Subject: Supplement No. 3
Geotechnical Investigation
Proposed Single Family Residence
Portion Of Lot 3 Of Tract No. 5571
3725 Ventura Canyon Avenue
Sherman Oaks, California

This submittal is in response to the latest Geology And Soils Report Correction Letter dated February 3, 2006, by the Grading Division of the Department of Building and safety of the City of Los Angeles (Log # 41904-02). For convenience, we have attached a copy of the Correction Letter with this Supplement No. 3. Our response is presented in the original order of the comments in the Review Letter.

GEOLOGY AND SOILS REPORT APPROVAL LETTER

GEOLOGIC CROSS SECTION B-B'

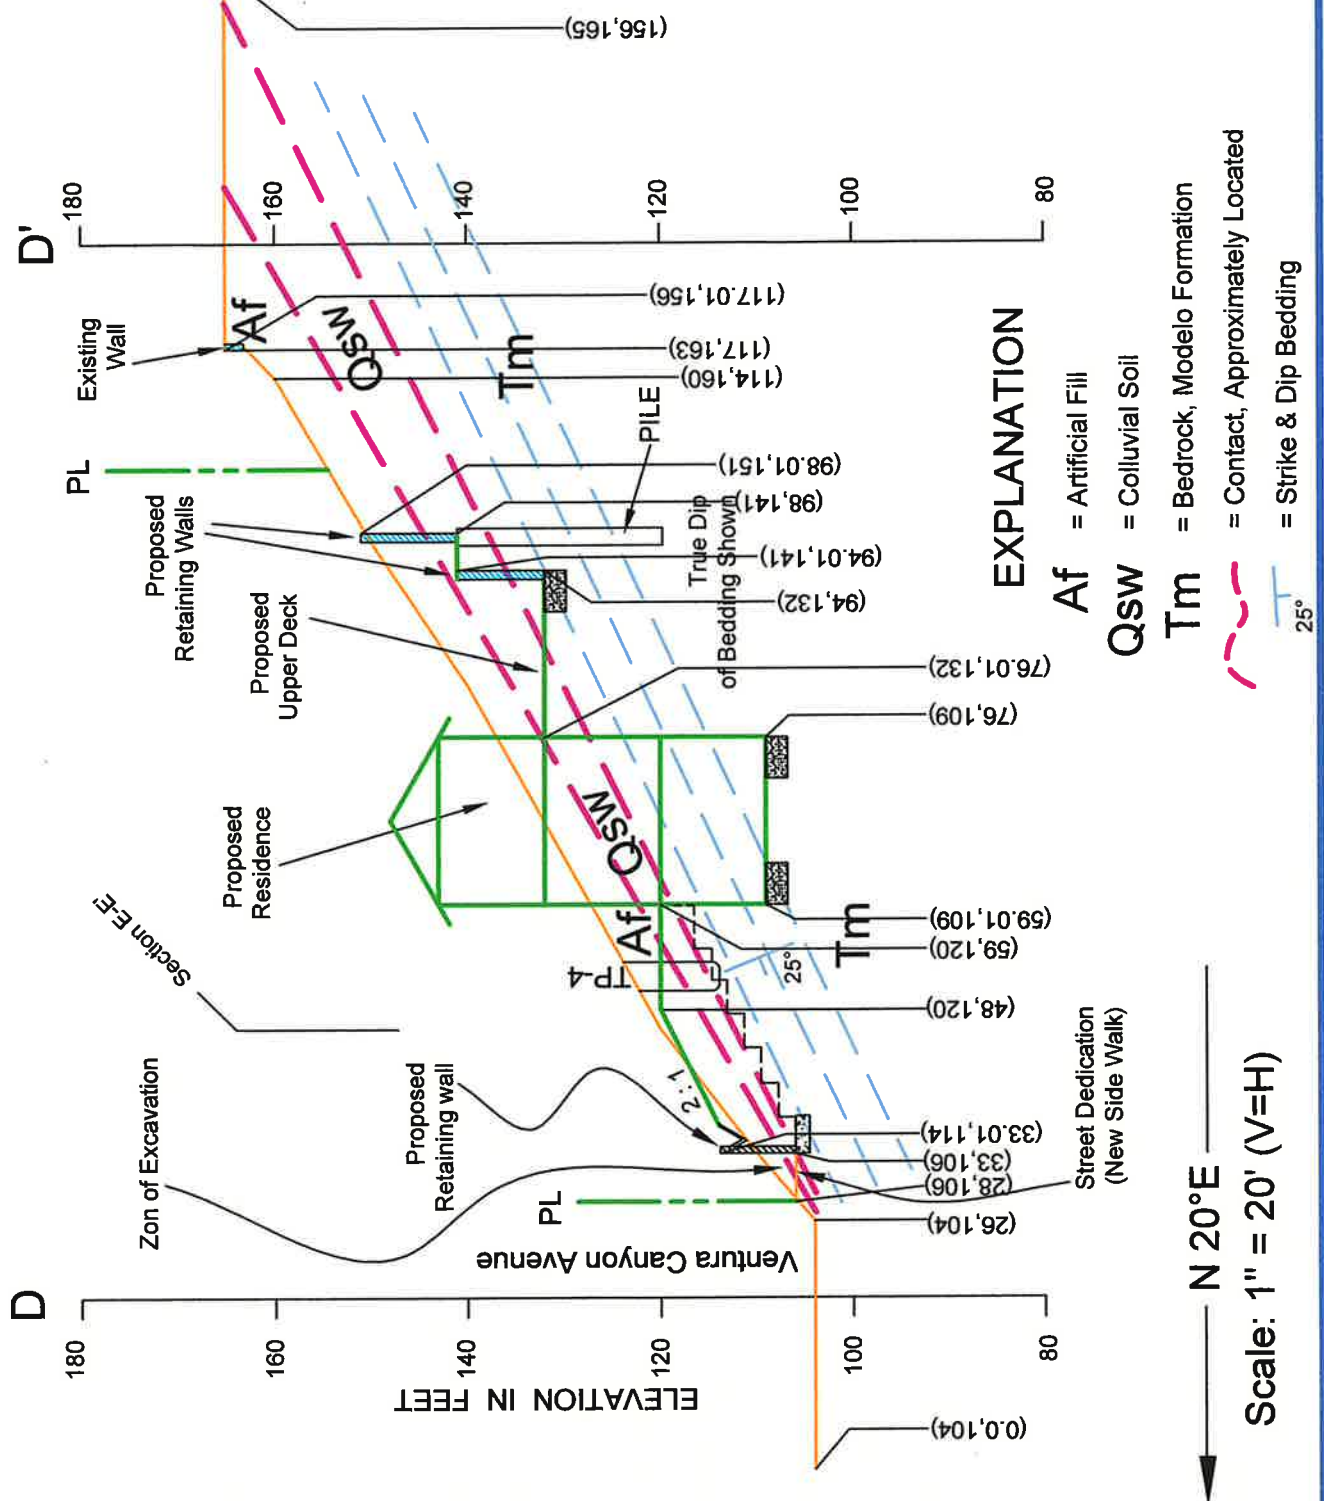
Our Cross Section B-B' has been revised to show a 2:1 shaved slope. A copy of the revised section B-B' is enclosed with this Supplement No. 3.

2. All new graded slopes shall be no steeper than 2H:1V (7010.2 & 7011.2). Please be informed that this includes all fill slopes steeper than 2H:1V including but not limited to the slope above the new retaining wall shown on the most-recent geologic cross-section B-B'.

GEOLOGIC CROSS SECTION D-D'

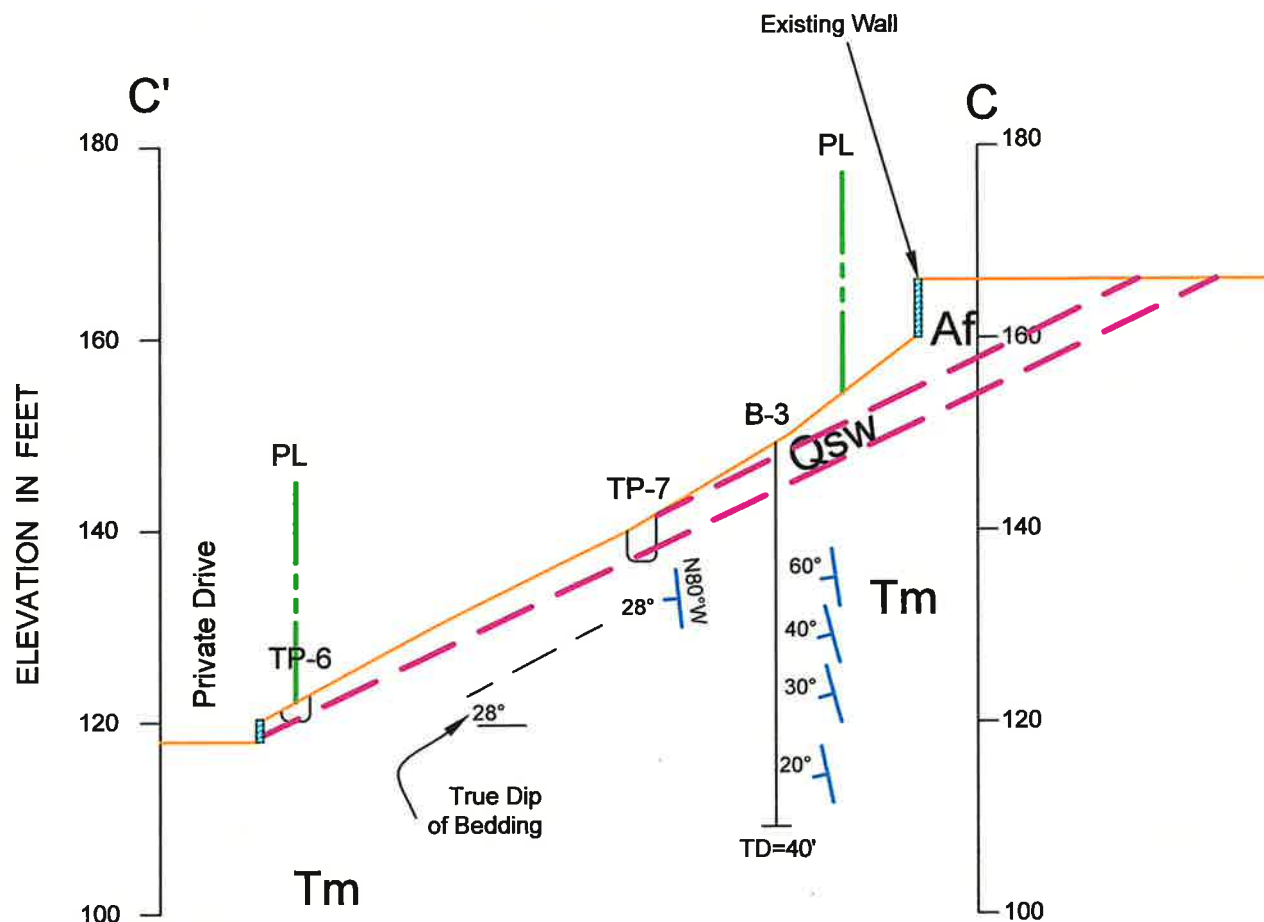
On the revised sections A-A', B-B' and D-D', the circle with a factor of safety of 1.5 are identified. All passive resistance should be taken below the planes having minimum factor of safety of 1.5.
